NPDES Compliance Inspection Report

Name and Location of Facility Inspected (For industrial users discharging to POTW, also include POTW name and NPDES permit number) St. James Park Subdivision Mt. Comfort & Hughmount Rd. Fayetteville, Arkansas	Entry Time/Date 1105 / 04-20-07	Permit Effective Date 09/11/06
	Exit Time/Date 1320 / 04-20-07	Permit Expiration Date March 31, 2008

RE: St. James Park Subdivision NPDES Permit Tracking No.: ARR151959

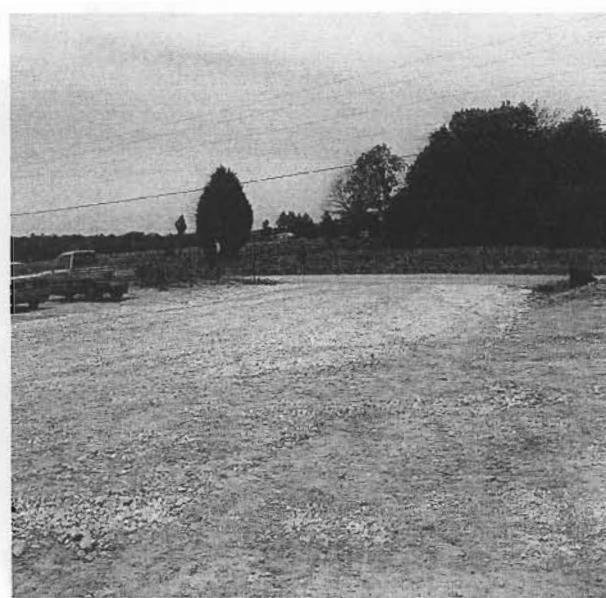
1. The Construction Site was not posted in a prominent place for public viewing.
Response: The notice is now placed visibly on the ADEQ/SWPPP mailbox.
2. SWPPP was not available on construction site for review.
Response: SWPPP is now available for viewing; it is located inside the ADEQ/SWPPP mailbox.
3. Inspections of the Construction site are not being performed in accordance with the SWPPP.
Response: Inspections are now being and have been performed in accordance with the SWPPP.
4. The SWPPP is not being kept current. Examples include the SWPPP site map not depicting the position of the relocated North Outfall and the current locations of the silt fencing.
Response: The SWPPP, including the comments mentioned above have been accurately updated.

Construction Site Permit has been properly posted and SWPPP is within the ADEQ mailbox.

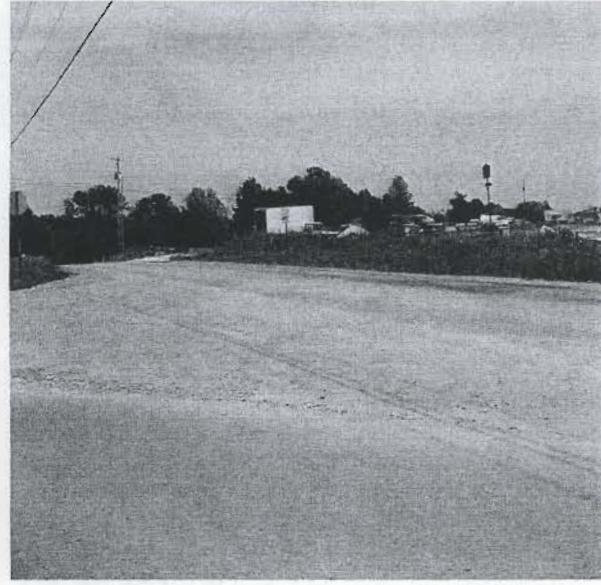
7. Presence of moderate off-site tracking at the west entrance.

B-stone has been added to the construction entrance to prevent offsite tracking.

West entrance roadway has been cleared of tracking and debris.
